URBAN COLLECTION AT PALMER VILLAGE
WATER DISTRIBUTION PLAN
WATER SYSTEM PLAN

SHEET 4 OF 10
JOB NO. 25149.01

**WP01 CROSSINGS 2-4 PROFILE
STA 4+50.00 TO 7+25.00**

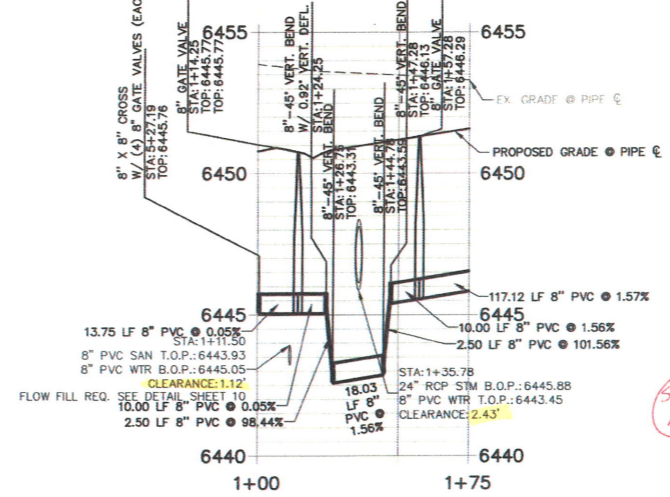
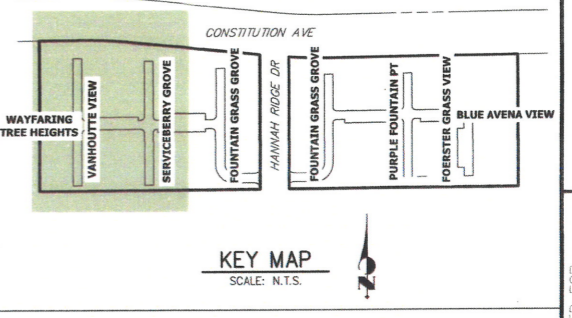
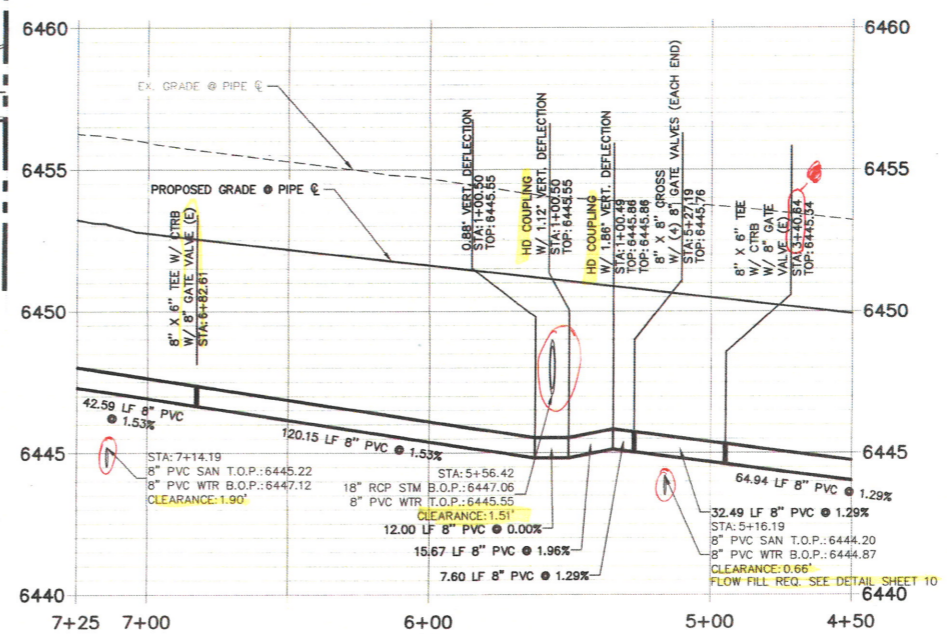
NOTE 1
NO DEAD END LINES
LOOP INTO EXIST OR
PROPOSE LINES
JKM/CMD
12-11-2020

CHECK LABELING
LOOKS WRONG
JKM/CMD

EXPLAIN SECONDARY
CONTAINMENT IN THIS
AREA JKM/CMD

SEE NOTE 1 ABOVE
JKM/CMD
12-11-2020

SEE CMD
NOTE 3

1. NOTE 2 SHOW WATER BORD OF SAN SEWER LIGHT FOR CLARITY (ALL SHEETS)
2. NO HIGH DEFLECTION COUPLINGS ALLOWED (SEE JR NOTE 9)
3. 8" LINE SIZE SEEMS OVERSIZED VERIFY LINE MEETS DESIGN FLOW.
4. INCLUDE SAMPLE STATION IN DEVELOPED AREA.

**WP01 CROSSING 1 PROFILE
 STA 3+50.00 TO 4+50.00**

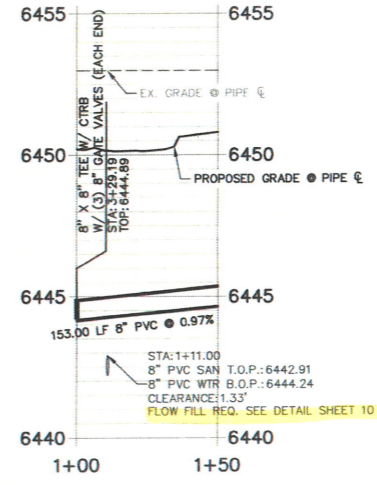
SEE NOTE 1
 SHEET 4
 JRM/CMD

SEE NOTE 3
 SHEET 4
 JRM/CMD

SEE NOTE 2
 SHEET 4
